# Technical Service Bulletin

SUBJECT:		No: <b>TSB-16-54-004</b>	
<b>TAIL LIGHT REMOVAL &amp; INSTALLATION PROCEDURE – SERVICE MANUAL REVISION</b>		DATE: <b>October, 2016</b>	
		MODEL: <b>2016 Outlander</b>	
CIRCULATE TO:	<input type="checkbox"/> GENERAL MANAGER	<input checked="" type="checkbox"/> PARTS MANAGER	<input checked="" type="checkbox"/> TECHNICIAN
<input checked="" type="checkbox"/> SERVICE ADVISOR	<input checked="" type="checkbox"/> SERVICE MANAGER	<input type="checkbox"/> WARRANTY PROCESSOR	<input type="checkbox"/> SALES MANAGER

This TSB updates the Chassis Electrical section of the affected Service Manuals to correct a reference in Tail Light removal and installation.

### TAIL LIGHT REMOVAL AND INSTALLATION

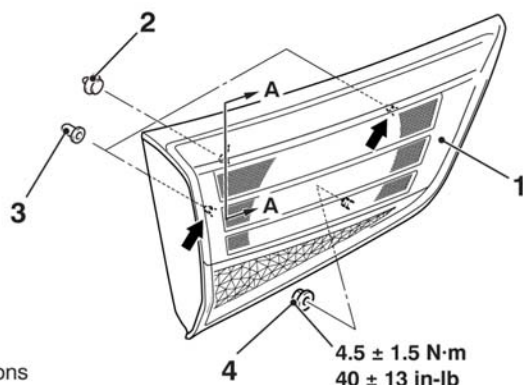
Please make the indicated changes to the 2016 Outlander Service Manual, Group 54A – Chassis Electrical → Rear Combination Light → Tail Light → Removal and Installation.

~~Pre-removal and Post-installation Operation <Incorrect>~~  
~~• Liftgate garnish Removal and Installation (Refer to GROUP 51-Liftgate garnish).~~

Pre-removal and Post-installation Operation <Correct>  
 • Liftgate Trim Removal and Installation  
 (Refer to GROUP 52A-Liftgate Trim).
